**Re: Carrier Corporation, Thompson Road Facility, Syracuse, New York
Corrective Action Order – Index CO 7-20051118-4
CO Update 2008 – Soil Vapor Intrusion Work Plan (rev. 2) and Response to Comments**

Response to Comments
NYSDEC Comments on SVI CMS Work Plan — March 10, 2009
Carrier Corporation, Syracuse, New York
May 9, 2009

**CORRECTIVE MEASURES STUDY WORK PLAN
SOIL VAPOR INTRUSION
(Amended per NYSDEC Comments dated 2/24/09)**

**United Technologies/Carrier
Thompson Road Facility
Syracuse, New York**

FIGURE 4
PROPOSED MH/STORM LINE
SVI SAMPLE LOCATION
CARRIER CORPORATION
SYRACUSE, NEW YORK

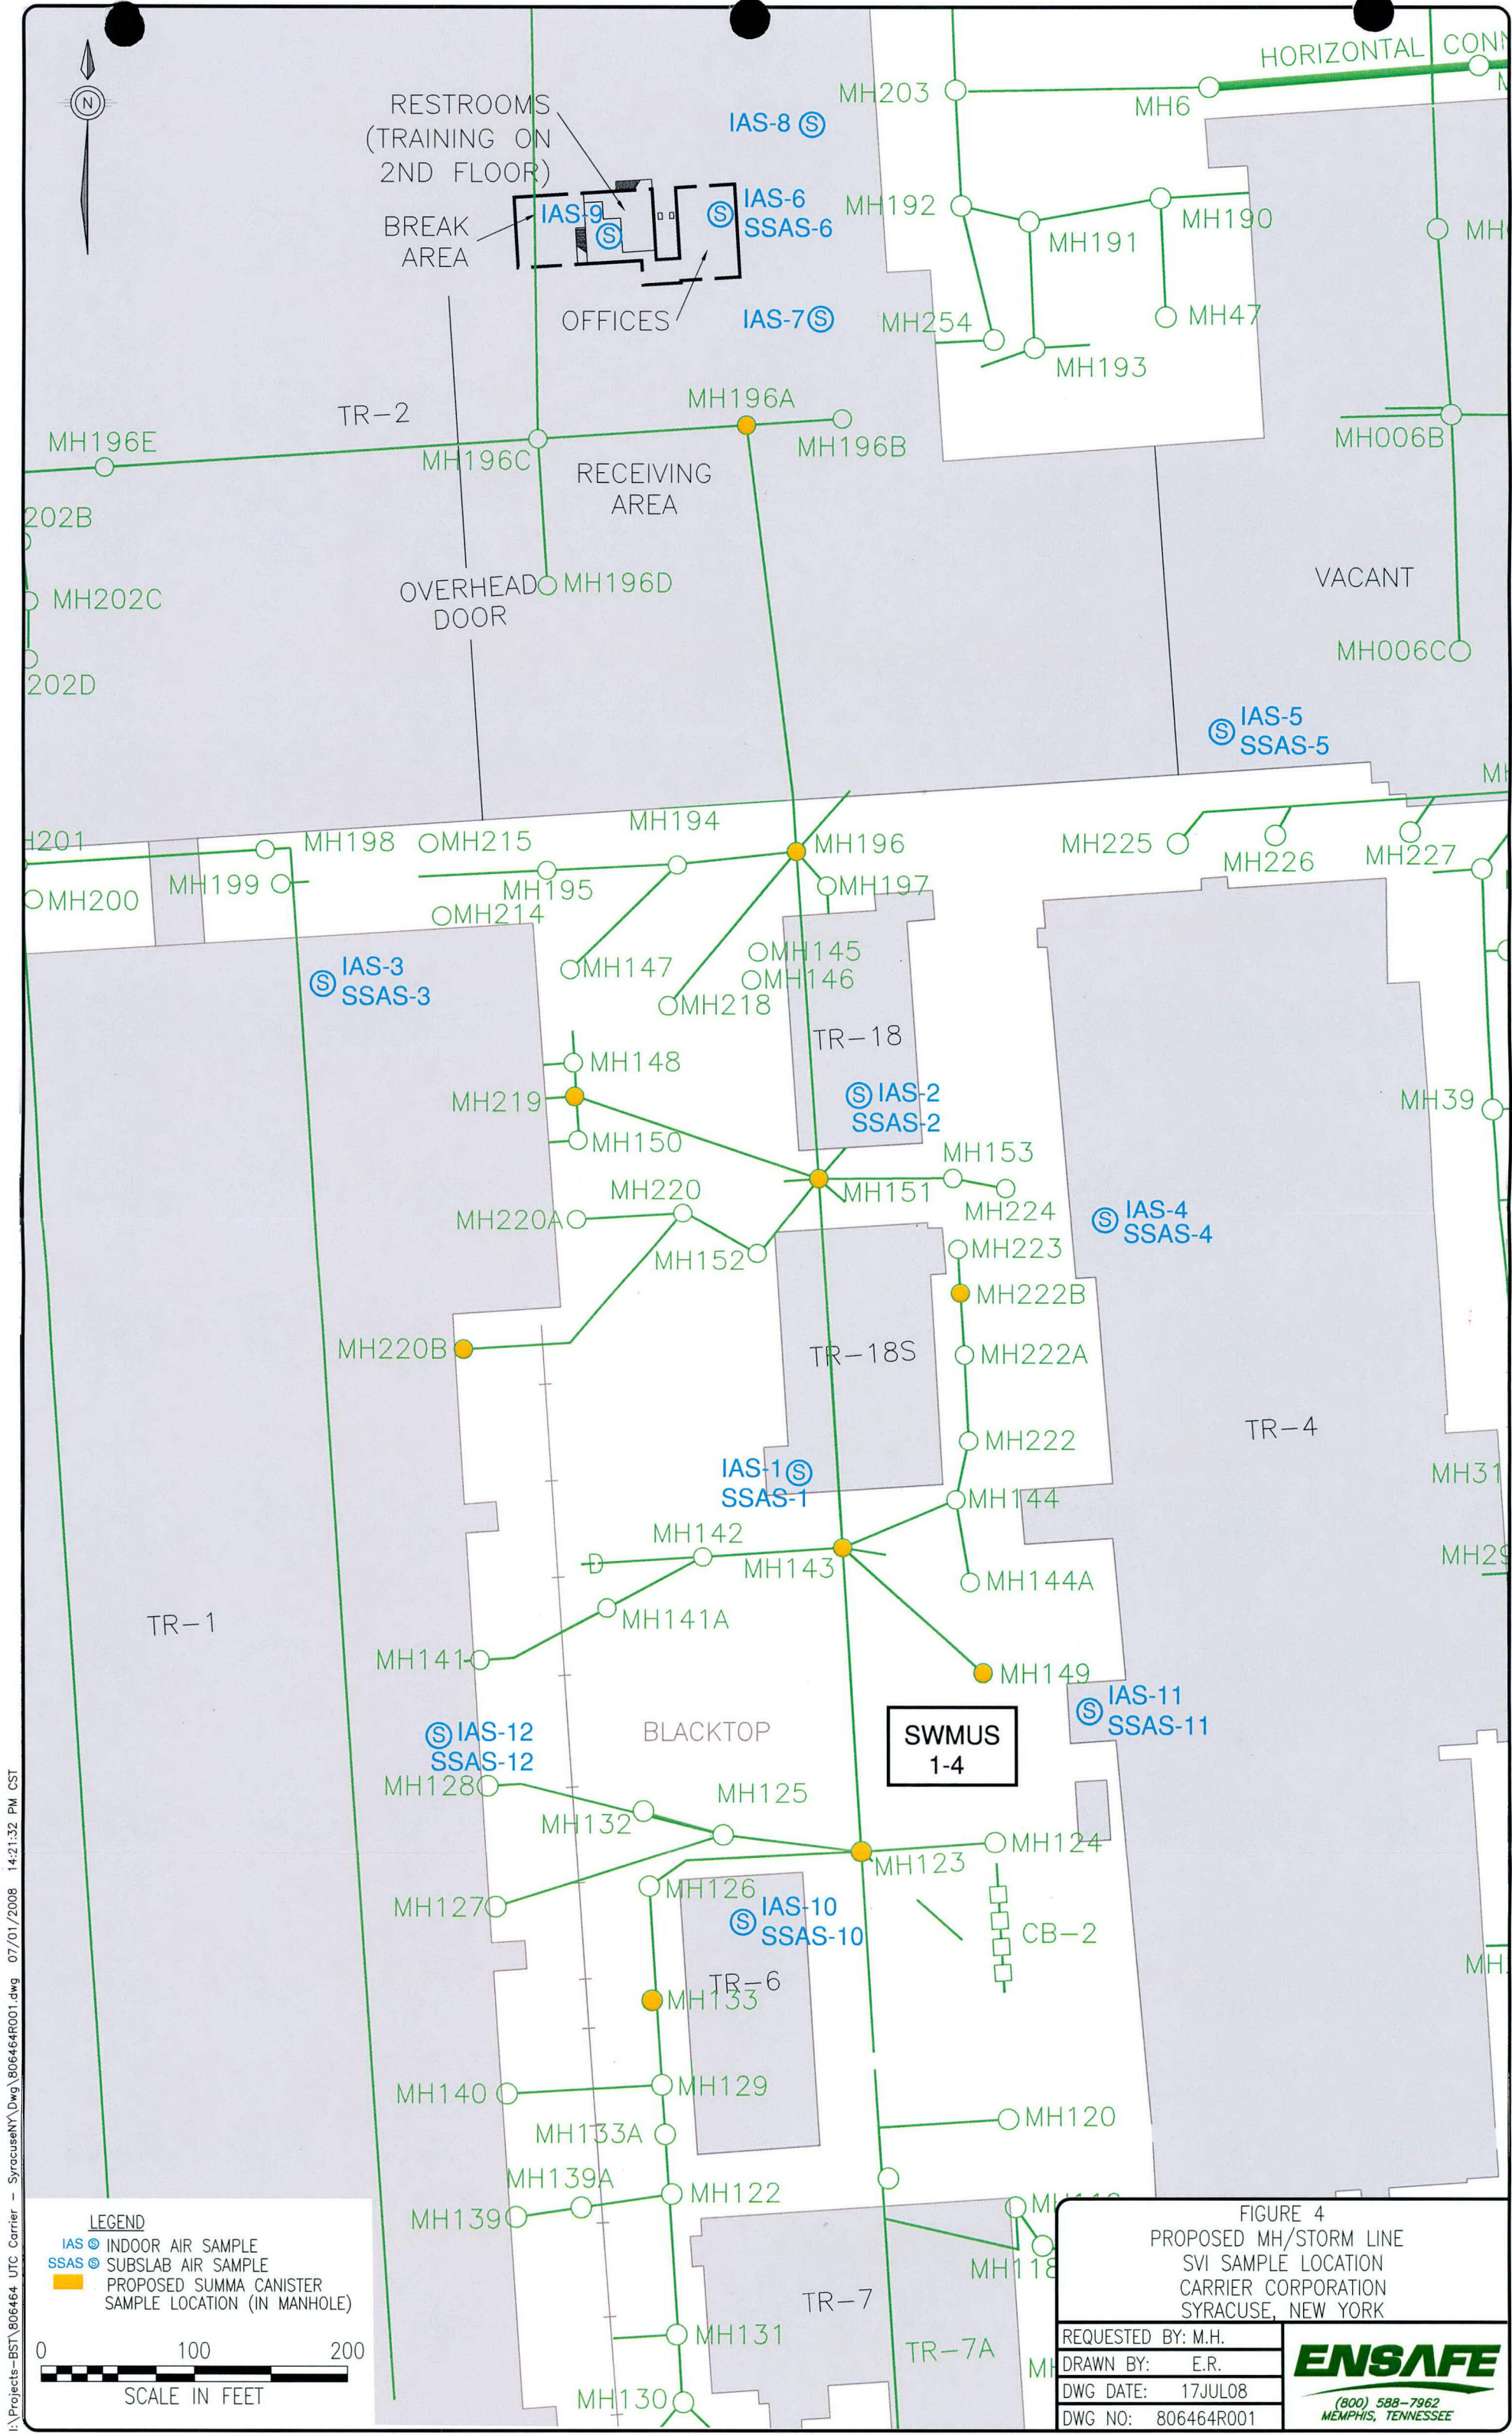
Comment 1: *Section 5.2, Inline Vapor Sample Collection is unclear whether it is calling for sampling within the manhole, the storm line and the bedding, or a sub-set of these. When the construction details are known and specific sampling points are proposed, all three should be considered to be potential monitoring points.*

Response 1: Carrier agrees that when construction details are known, the vapor collection points may be advisable in the manholes, storm lines, and in the bedding material underlying the storm lines. Vapor sampling in the manholes and storm lines appears straightforward (much like indoor air samples are collected), with the exception that placement of a Summa canister and follow-up readings in storm lines (not manholes) would require confined space entry. The value added by obtaining data within the storm line will be assessed once manhole vapor samples and bedding material samples are reviewed.

The ability to collect a vapor sample in the bedding material underlying the storm line will be determined by the construction characteristics of the storm line (i.e. was the line placed on gravel, sand, or directly on compacted earthen material) and the depth to groundwater in relation to the depth of the storm line. Historic groundwater sampling shows the seasonal groundwater table to range from 6 to 13 feet below ground surface, and many portions of the storm line throughout the site are partially or completely below the groundwater table for at least part of the year, making soil vapor probe sampling infeasible.

Section 5.4 (formerly Section 5.2) of the work plan has been modified to reflect the potential for additional monitoring locations. Reference to obtaining a sample from the storm line itself, has been removed, but will be evaluated once manhole vapor samples and soil vapor probe samples have been reviewed.
